Technical Service Information

THM 440-T4 SLIPS IN REVERSE

Figure 1

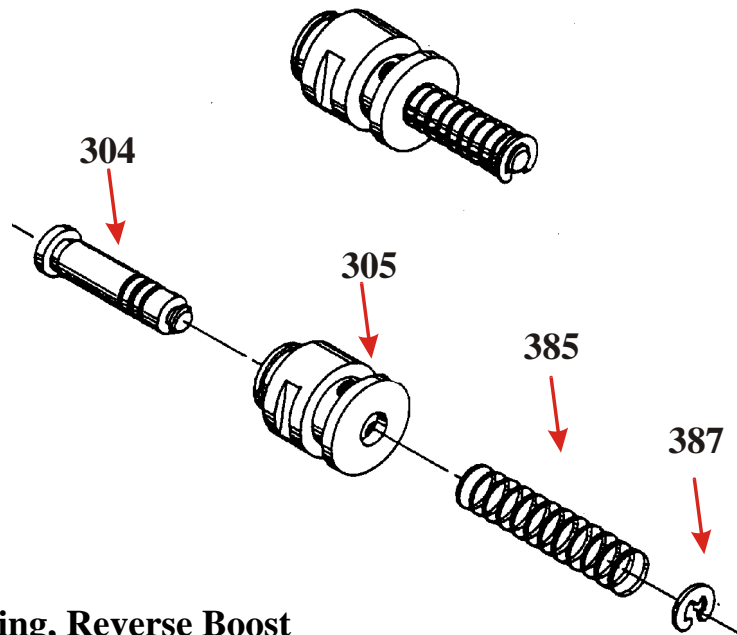
COMPLAINT: Slips in reverse under light or medium throttle only - heavy throttle OK.

CAUSE: Not enough line pressure in reverse to keep reverse band firmly applied.

CORRECTION: Remove 4 coils from the reverse boost valve spring (see figure below). This will raise line pressure in reverse to approximately 85 PSI, which is 15 PSI higher than original and provides more holding power for the reverse band.
